SIB 65 05 19

RECALL 19V-015: DRIVER'S FRONT AIR BAG MODULE – PRIOR PARTS REPLACEMENT

This Service Information bulletin (Revision 5) replaces SI B65 05 19 dated **October 2019**

GRUSB6519-01

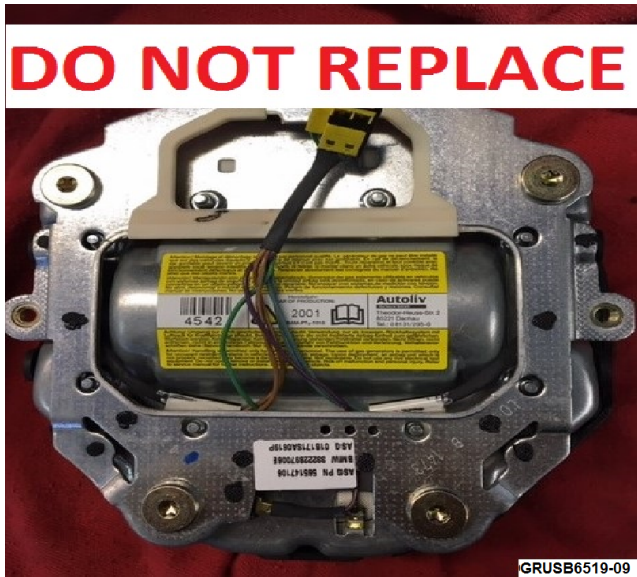
<p style="text-align: right; font-size: small;">GRUSB6519-07</p>	<p>Basic Steering Wheel Equipped Vehicles (with or without MFL button controls)</p> <p>This steering wheel's air bag is NOT affected, air bag removal for inspection is NOT necessary</p> <p>Submit a claim for checking only.</p>
 <p style="text-align: right; font-size: small;">GRUSB6519-08</p>	<p>Optional Sports Steering Wheel Equipped Vehicles (with or without MFL button controls)</p> <p>This steering wheel's air bag MAYBE affected, remove, inspect and replace the air bag as necessary.</p> <p>Submit a claim for the inspection or the inspection/replacement repair that applies.</p>
	<p>Vehicles equipped with Optional Sports Steering Wheel only</p> <p>1. Remove the driver's air bag in accordance with repair instructions REP 32 34 020 "Removing and installing/replacing air bag units".</p>
	<p>2. Check the label on the back of the driver's air bag.</p> <p>Is the label yellow with a white number sticker with printed serial number BAM XXX - 1085 (as shown) printed below the bar code?</p>

YES- replace air bag following attached procedure.
